**ADDENDUM
NO. 1**

March 3, 2021

Scott County School District 1 – Austin Elementary Additions & Renovations and HS Pool Renovation
Austin, IN 47102

ADDENDUM NO. ONE

2 WALL SECT @ UNIT C SPED RR
SCALE: 1/2" = 1'-0"

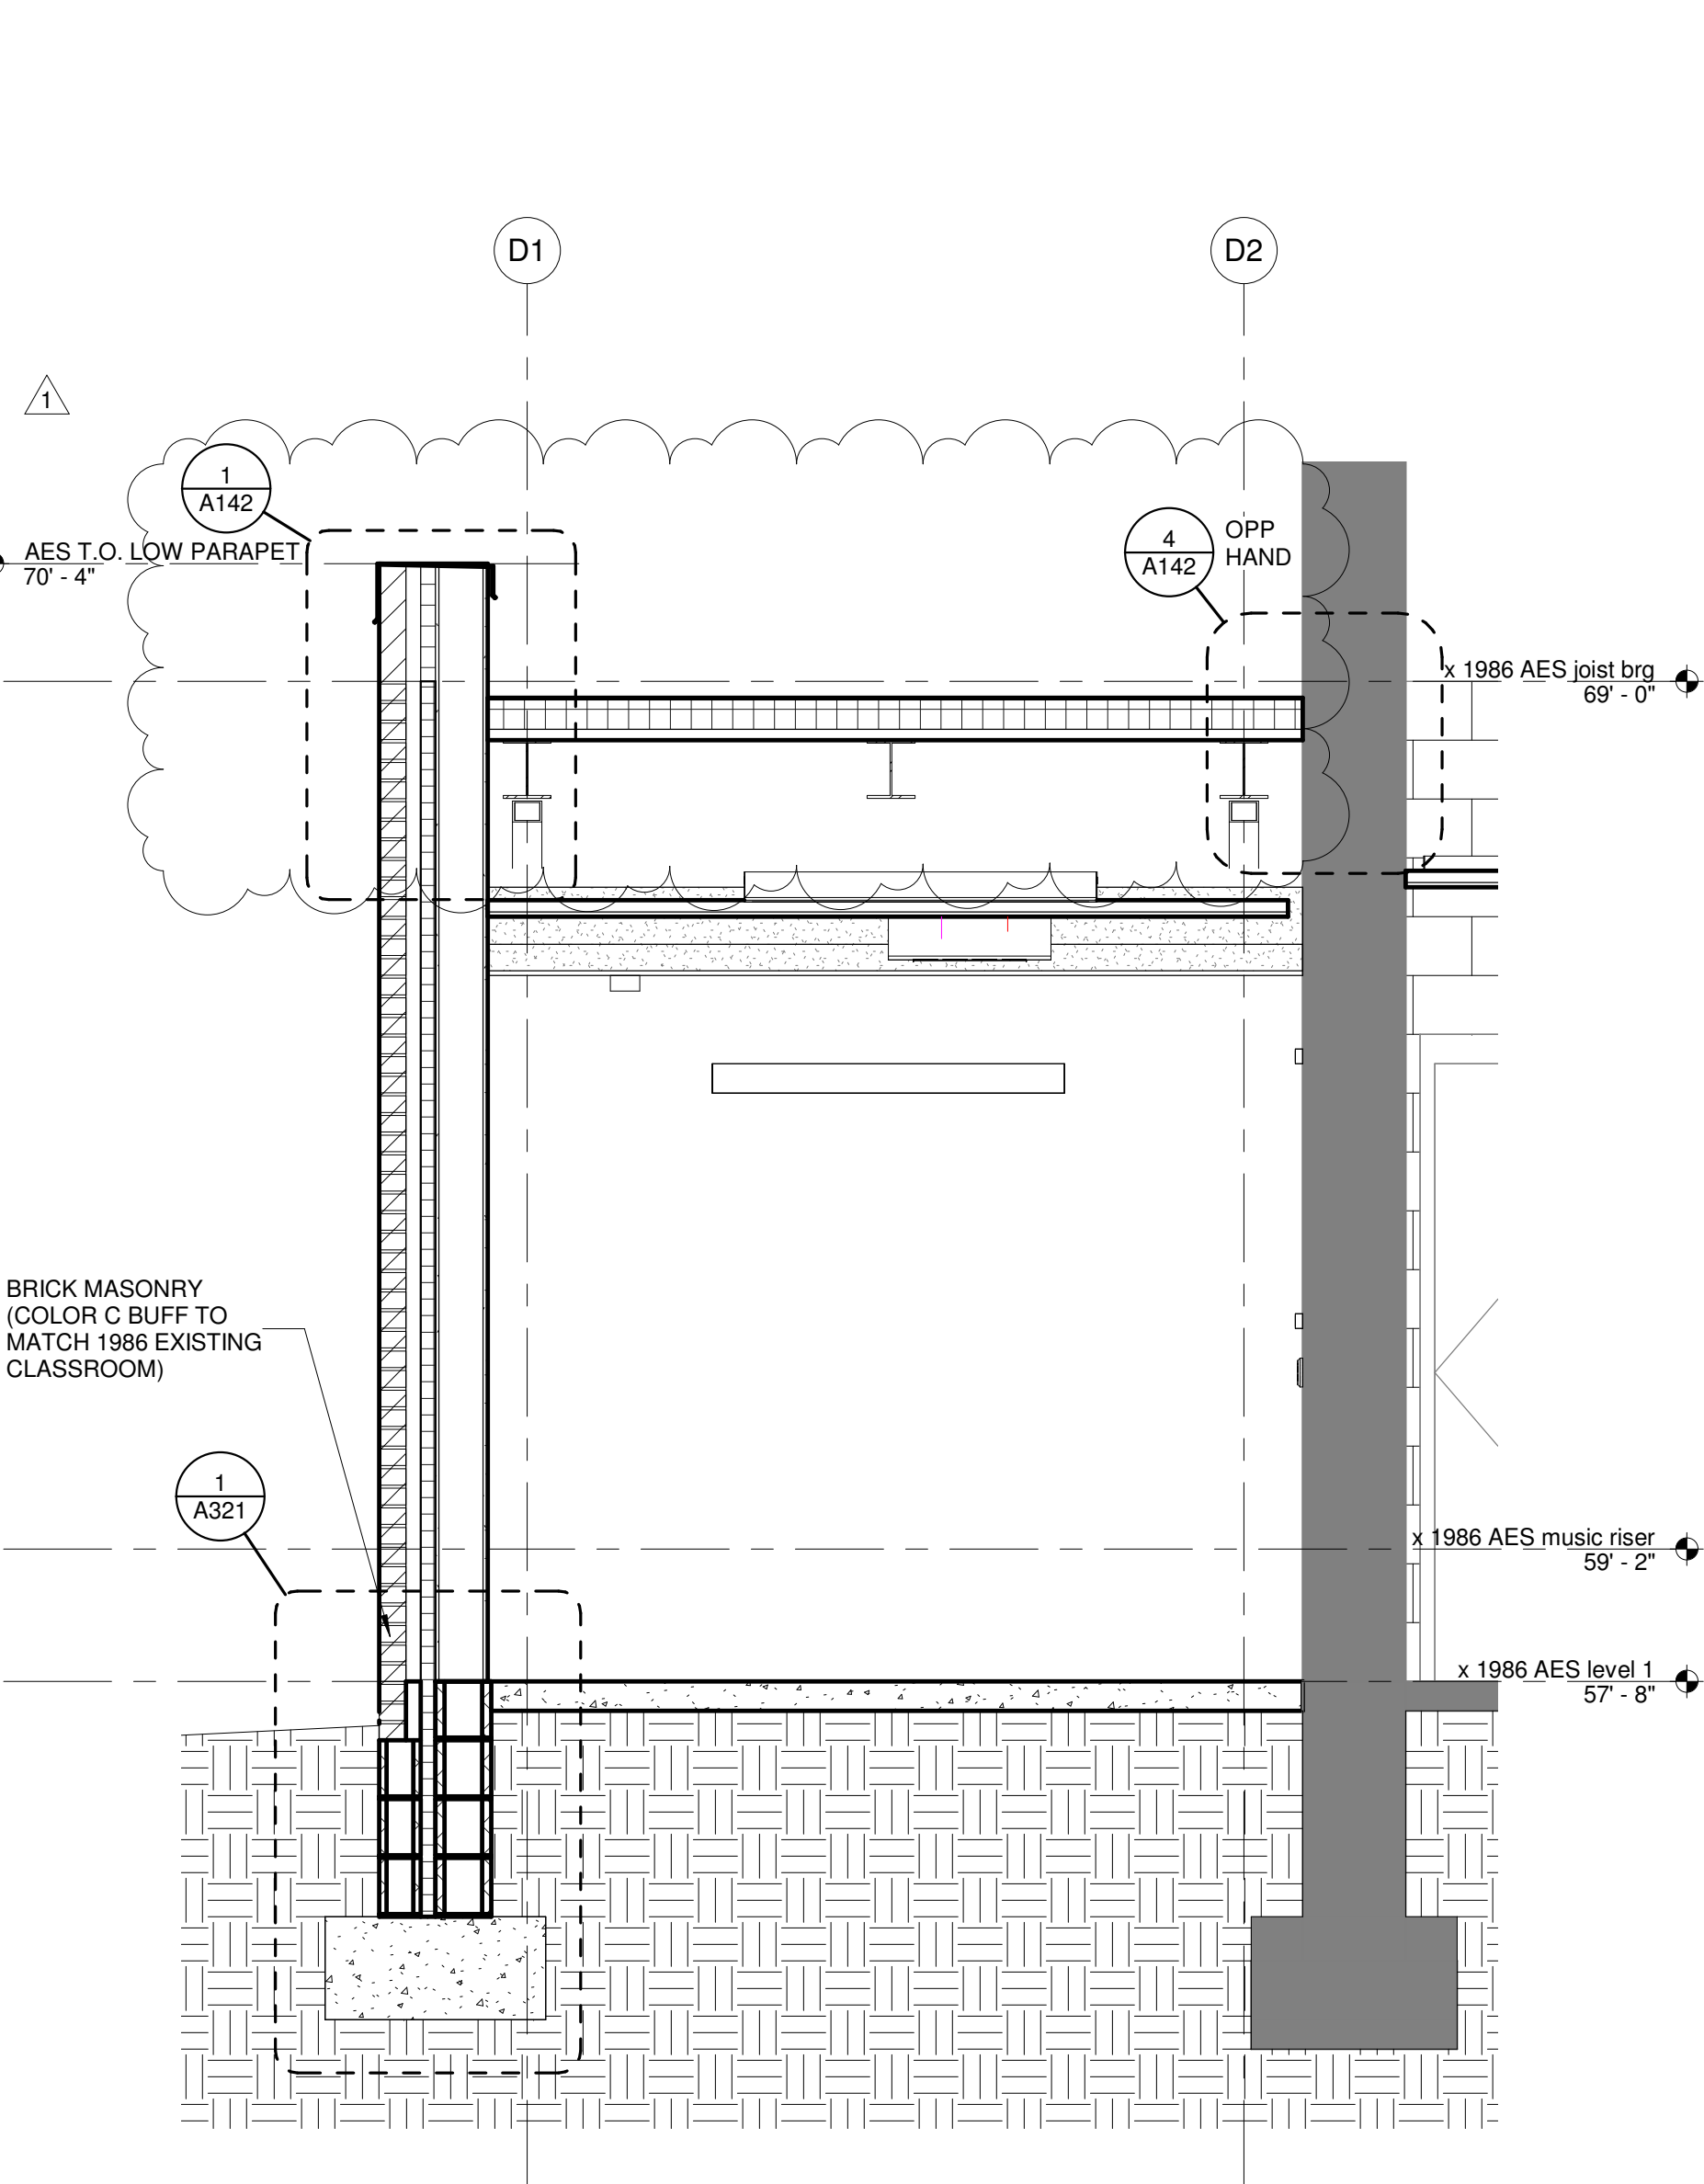
10. Drawing No.: A313
Drawing Sheet Title: WALL SECTIONS
Revision:
Modified Unit D Corridor addition structure and parapet height at detail 1 on attached revised sheet.

MECHANICAL SCHEDULES

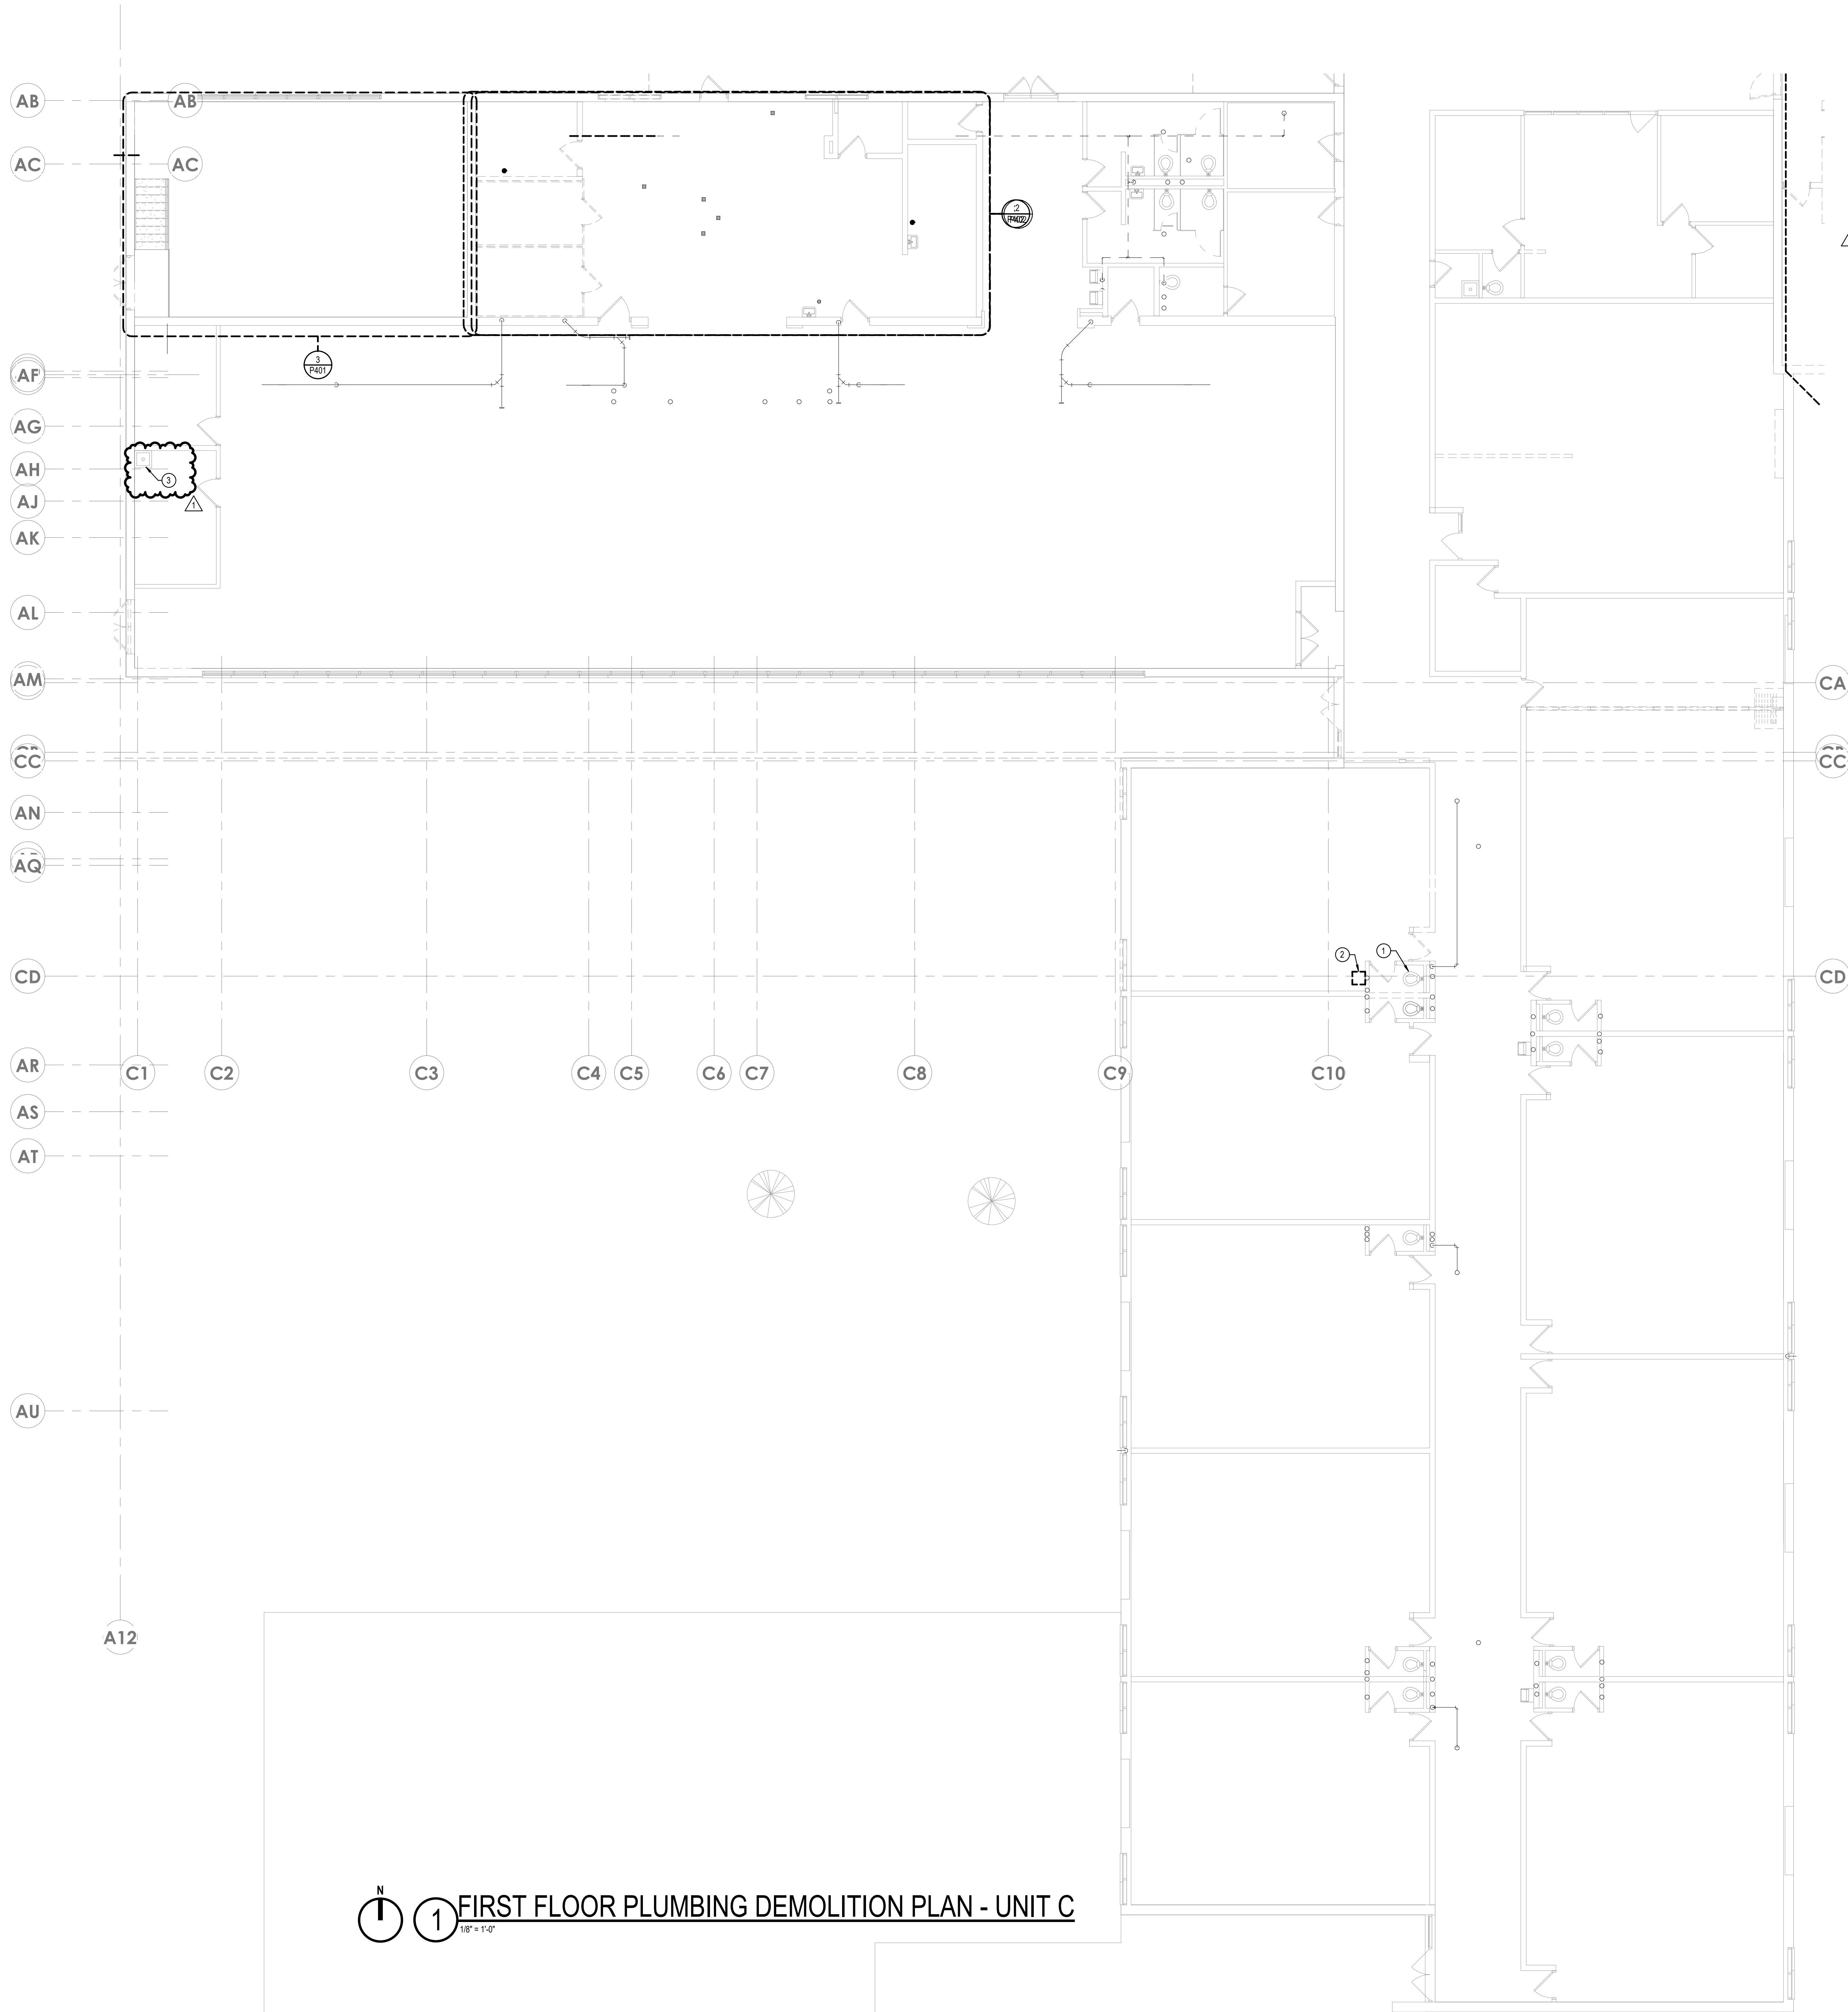
1. Drawing No.: MH101C
Drawing Sheet Title: FIRST FLOOR MECHANICAL PLAN – UNIT C
Revision: Add return air grille RG3 in corridor.
See attached drawing.
2. Drawing No.: M601
Drawing Sheet Title: MECHANICAL SCHEDULES
Revision: Revised CUSTOM AIR HANDLING ROOF TOP UNIT SCHEDULE,
Min cfm's and pre-heat coil data.
See attached drawing.
3. Drawing No.: M602
Drawing Sheet Title: MECHANICAL SCHEDULES
Revision: Revised LOUVER SCHEDULE,
Added note 1. Color selection by architect.
See attached drawing.

SECOND FLOOR PLUMBING PLAN - UNIT A

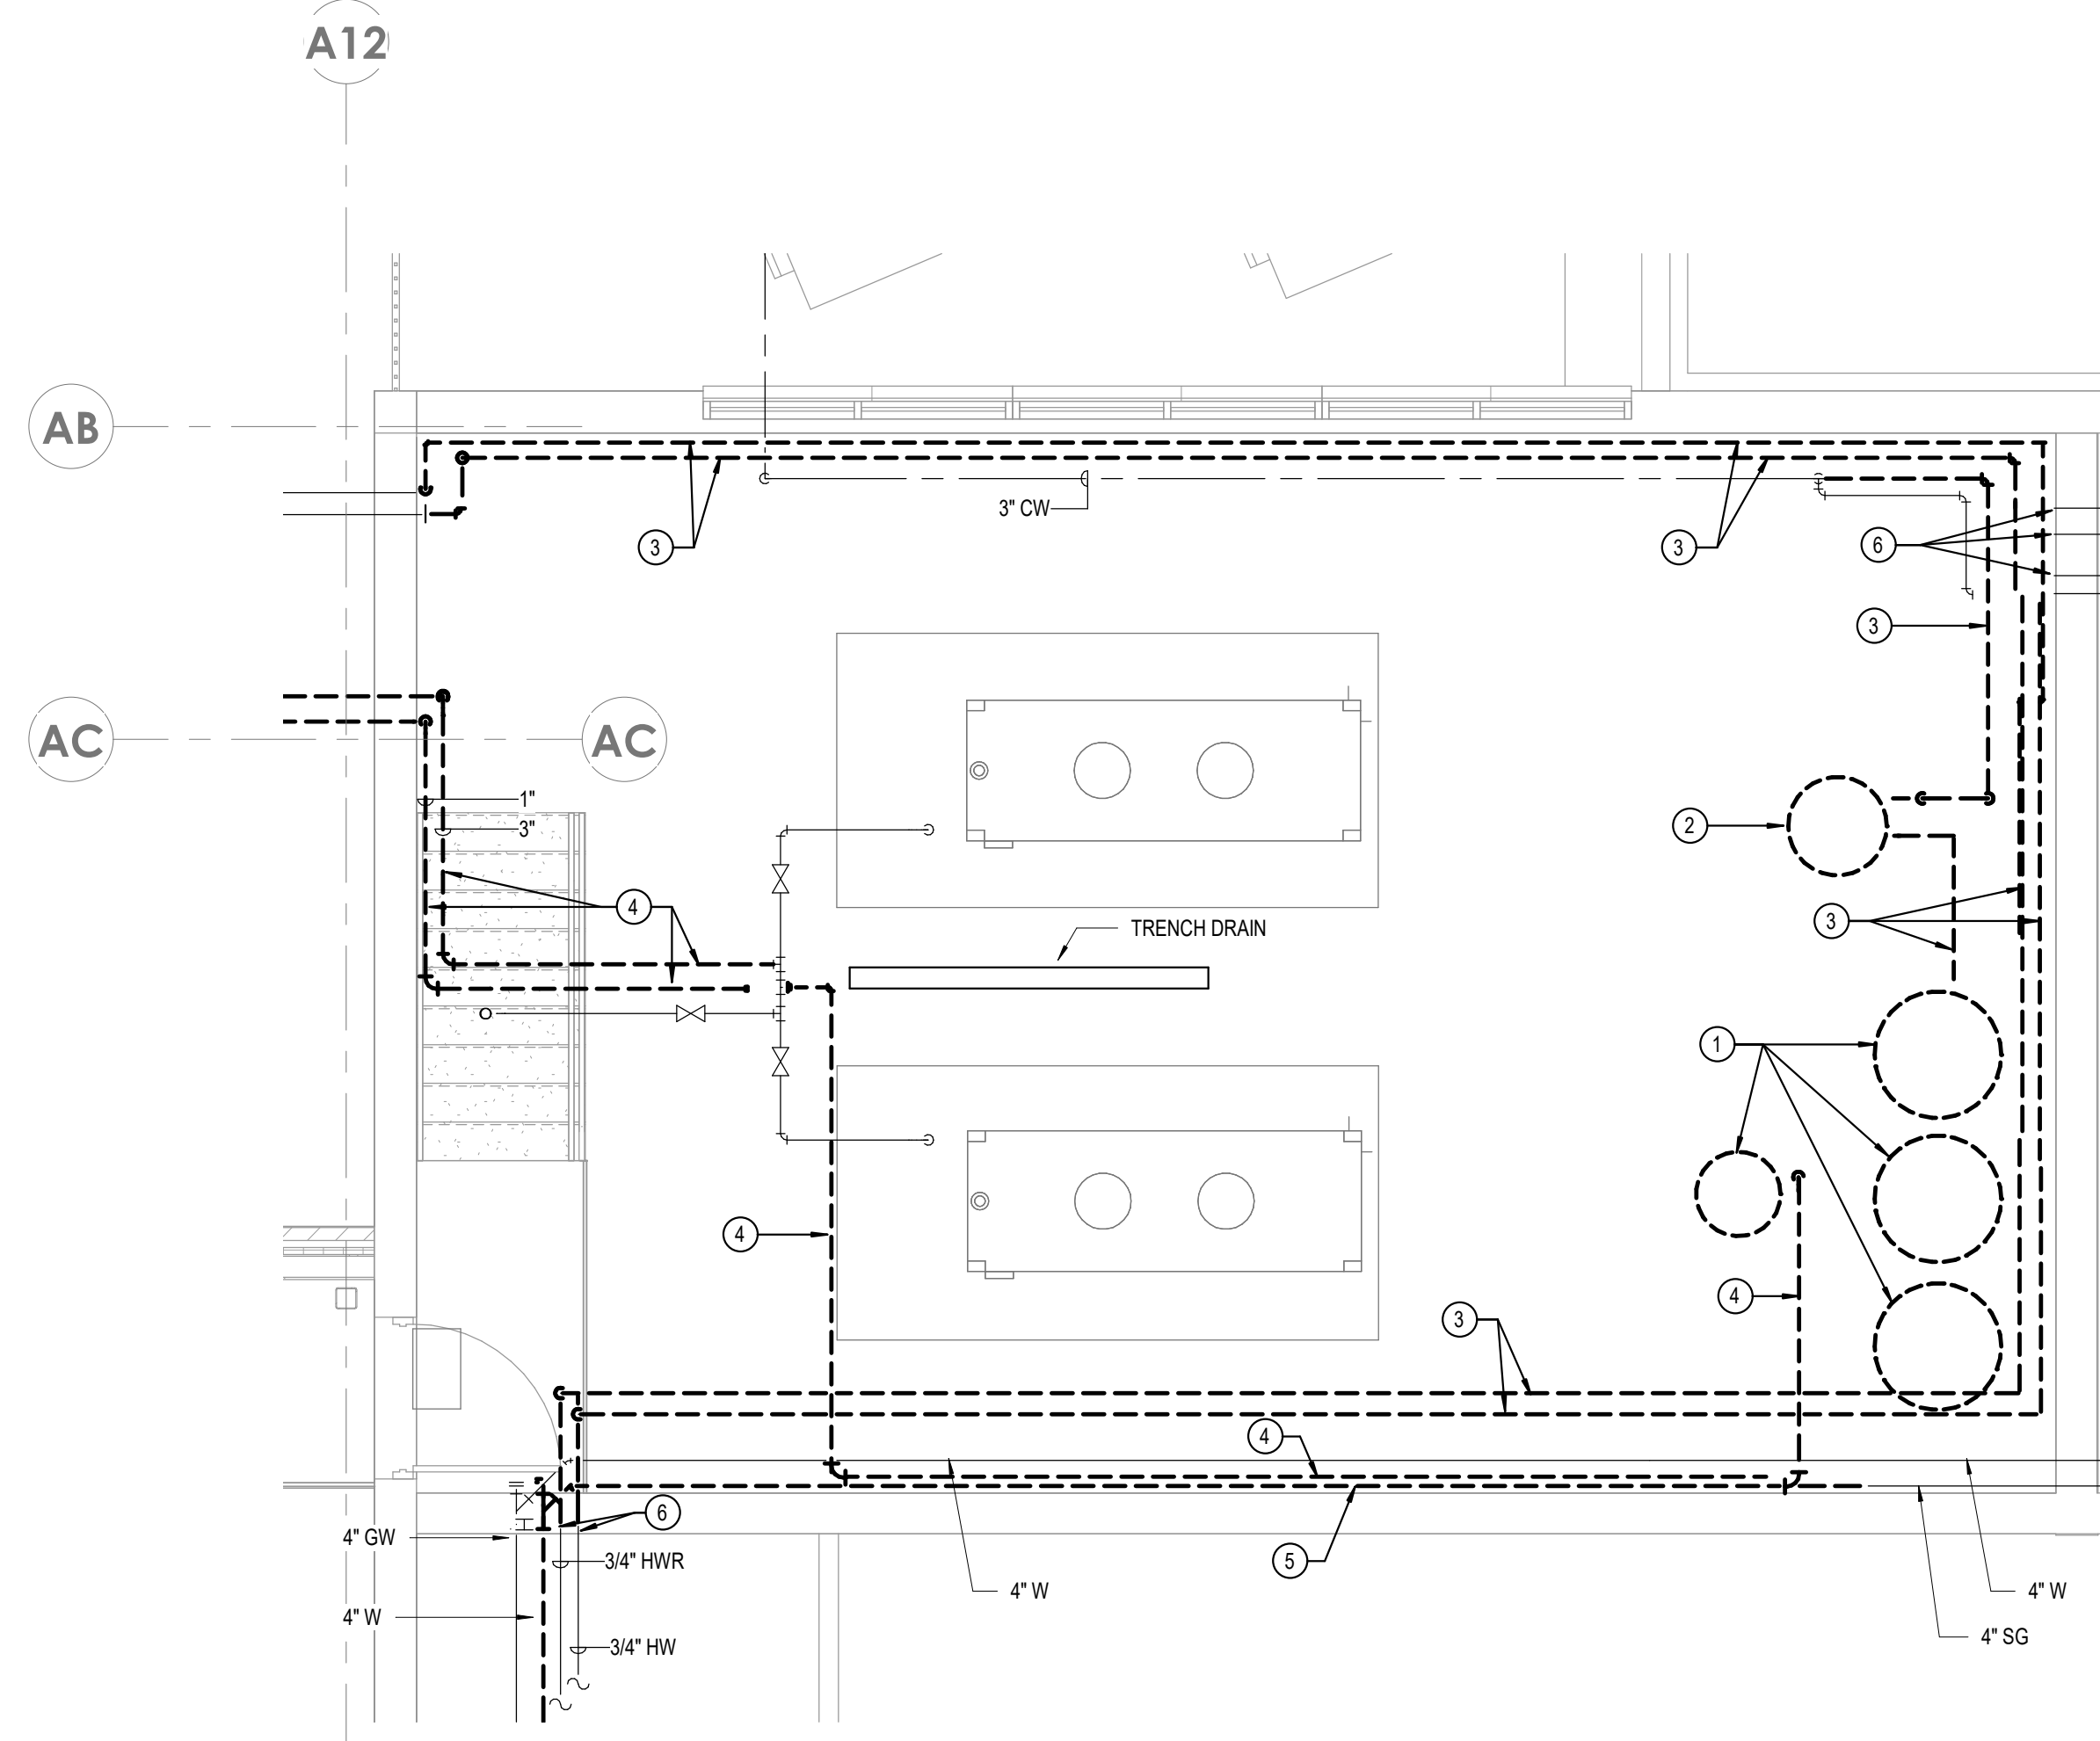
Drawing Sheet Title: FIRST FLOOR PLUMBING PLAN – UNIT C
Revision: Add Mop Basin (MB-1). See attached drawing.
4. Drawing No.: P102A
Drawing Sheet Title: SECOND FLOOR PLUMBING PLAN – UNIT A
Revision: Add Water Supply Box (WSB-1) for (1) refrigerator. See attached drawing.
